**GREATER NEW HAVEN WATER POLLUTION CONTROL AUTHORITY
PROCESS AIR COMPRESSOR SYSTEM FOR LOW LEVEL NITROGEN REDUCTION**

Project CWF 2019-04

ADDENDUM #2

August 25, 2023

PROCESS AIR FACILITY HVAC AIR FLOW SCHEMATIC AND SEQUENCE OF OPERATIONS

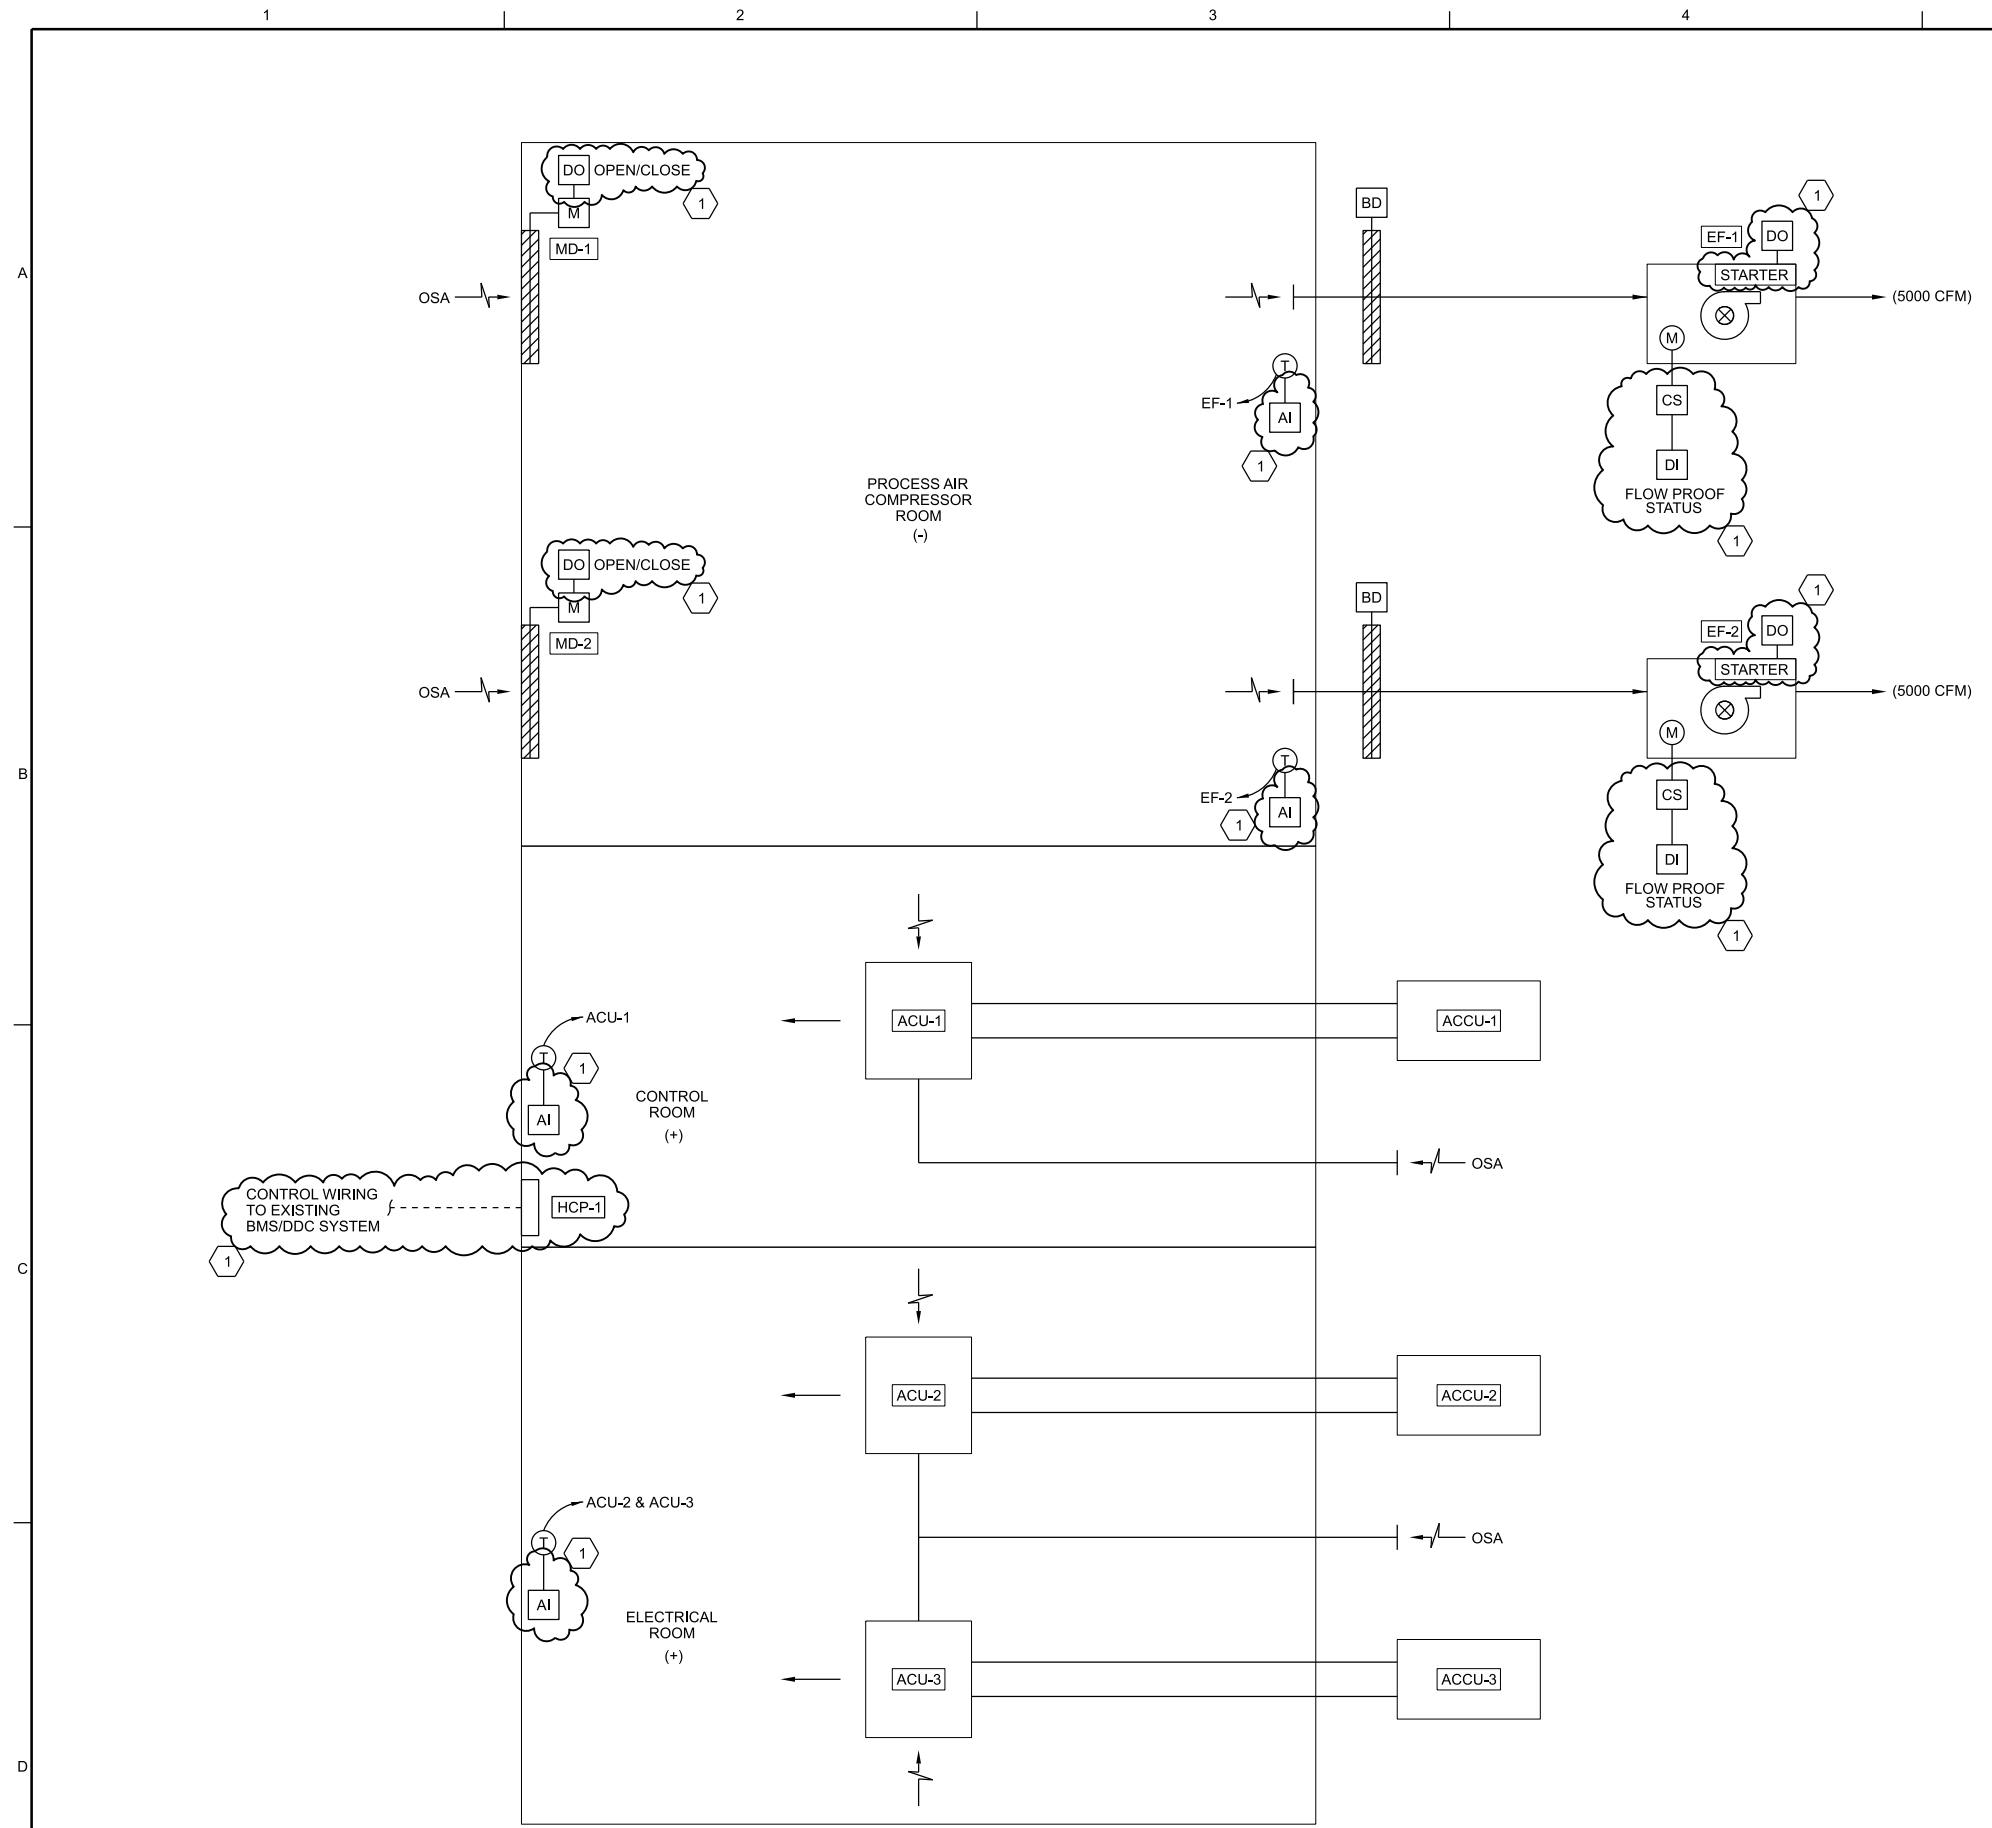
SYSTEM CONTROL SHALL BE VIA DDC HVAC CONTROL PANEL HCP-1 LOCATED IN THE CONTROL ROOM.

Jacobs
PROCESS AIR FACILITY
HVAC
FLOOR PLAN

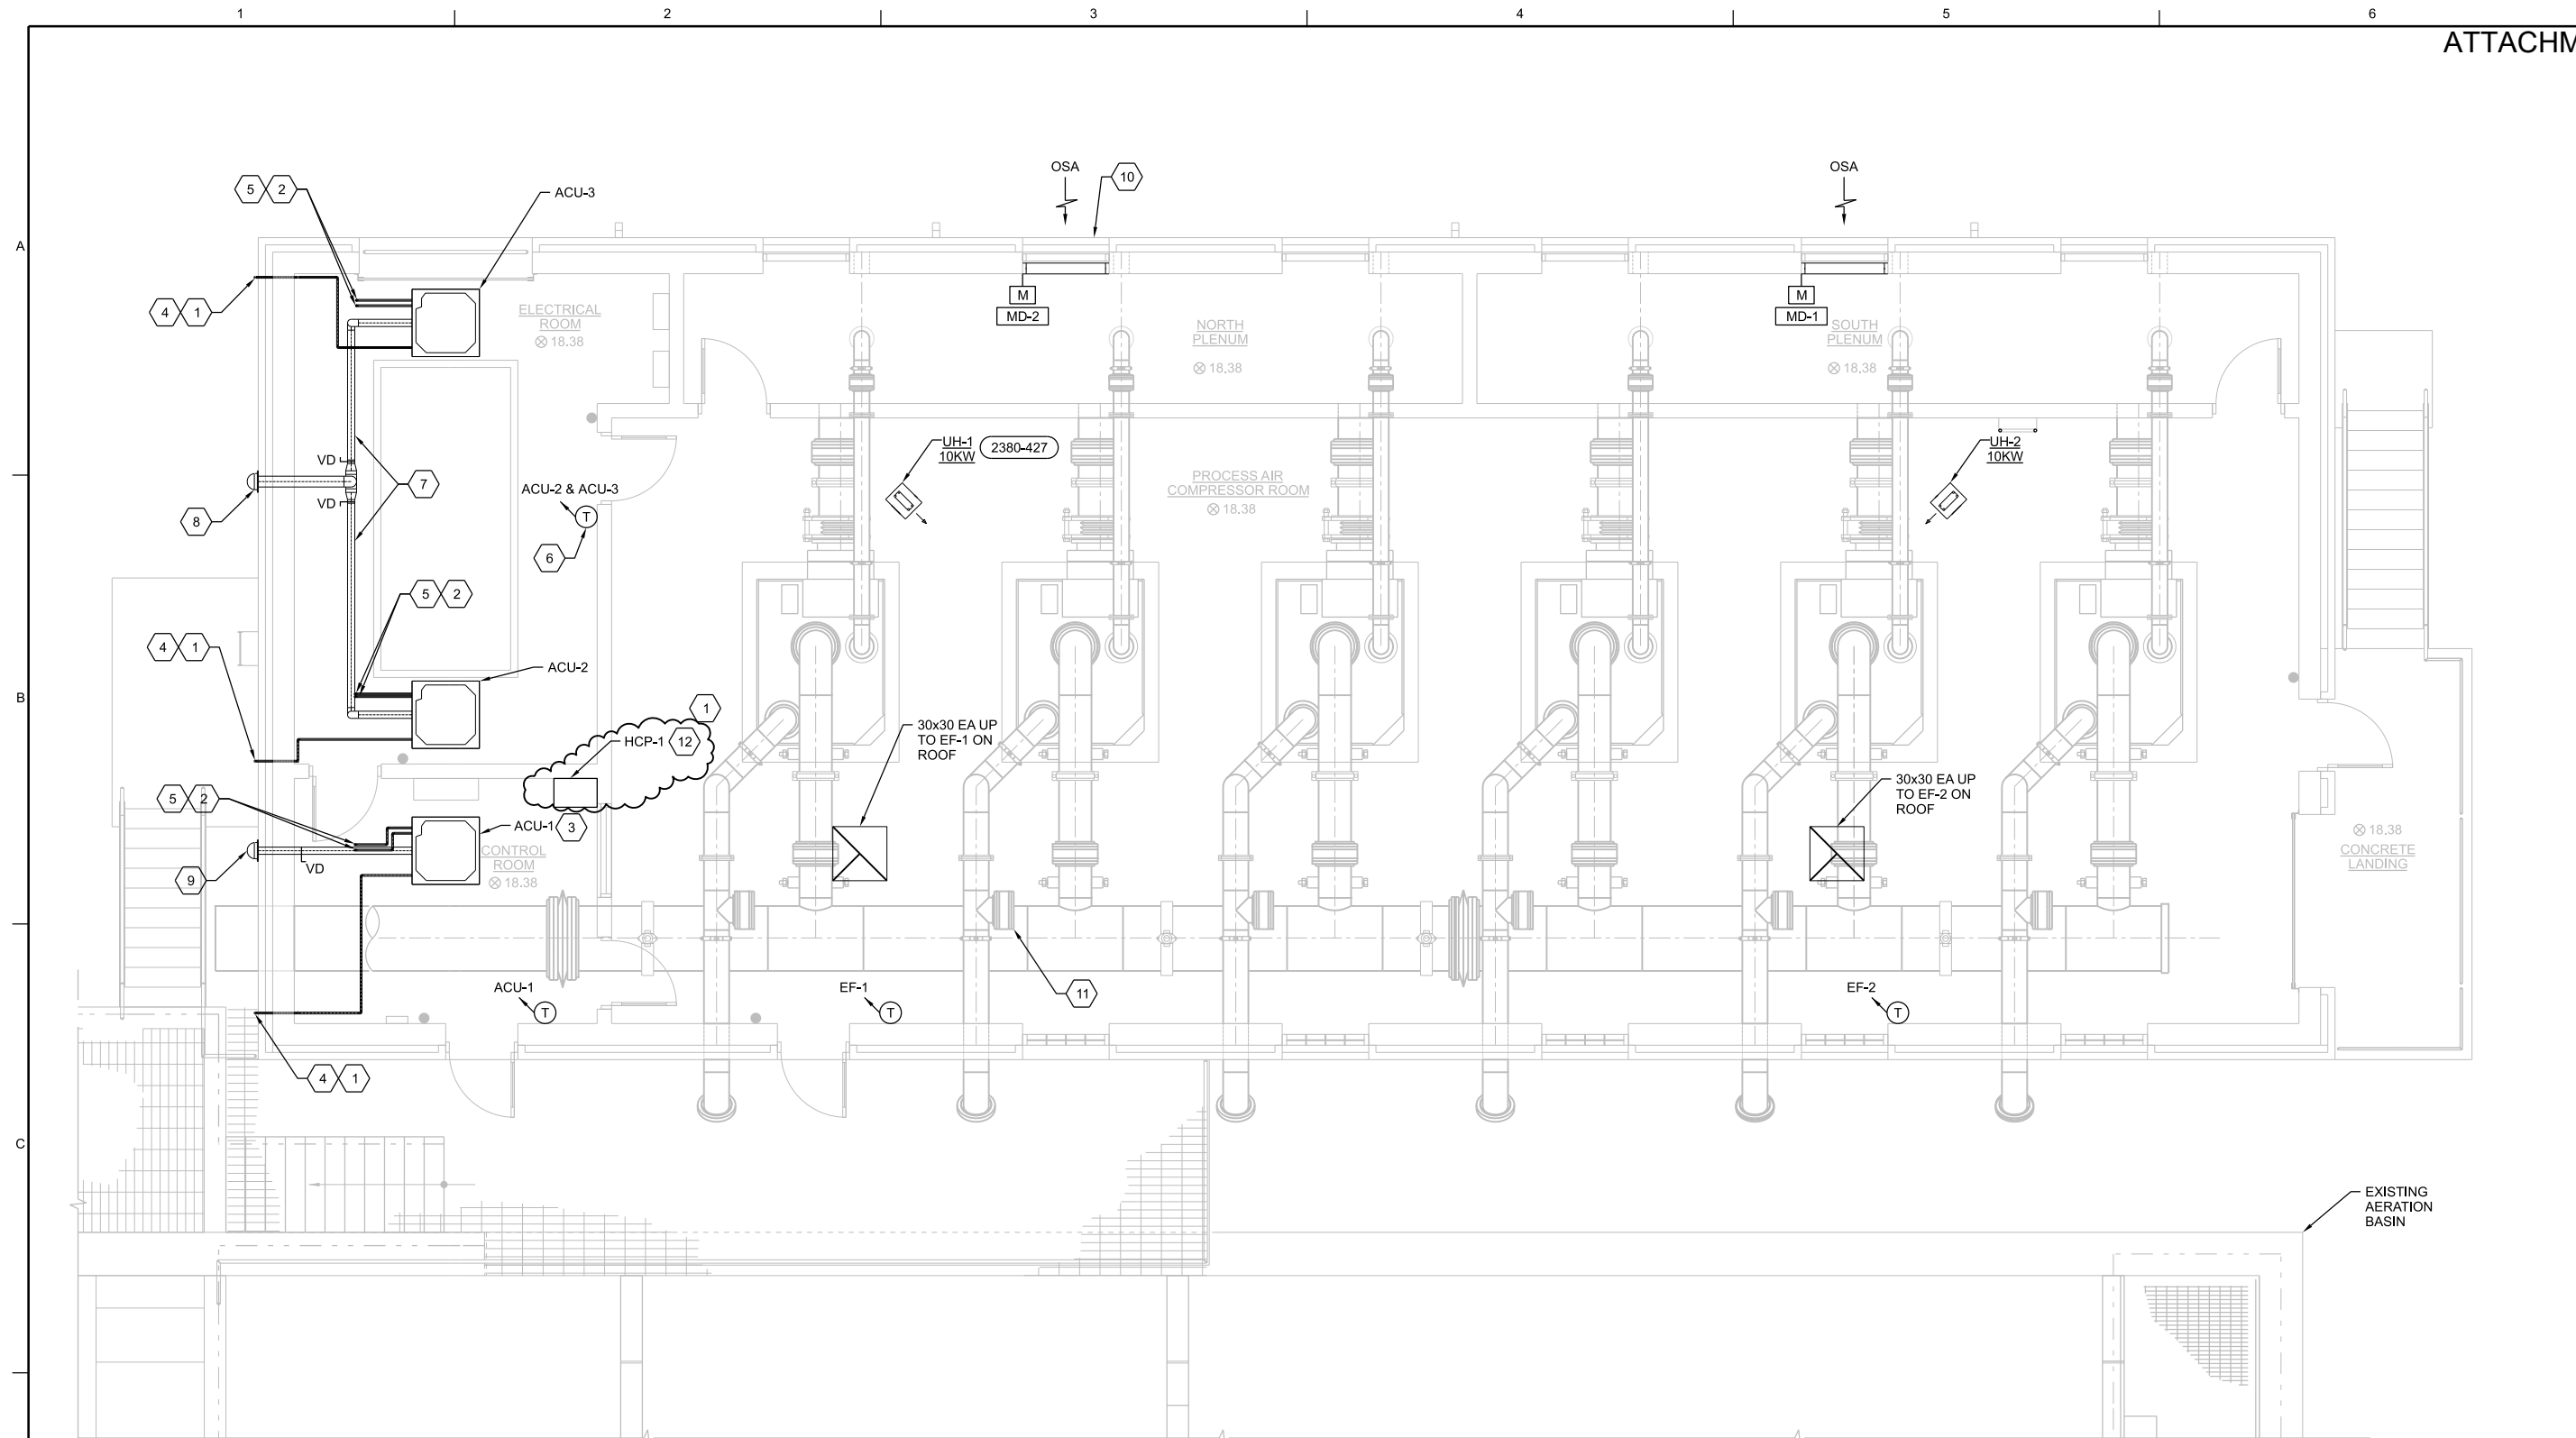
12. CONNECT NEW HCP-1 TO EXISTING PLANTWIDE BUILDING MANAGEMENT SYSTEMS (BMS). CONTRACTOR SHALL BE RESPONSIBLE TO ROUTE CONTROL WIRING TO EXISTING CONTROL SYSTEM AS REQUIRED. COORDINATE WITH OWNER.
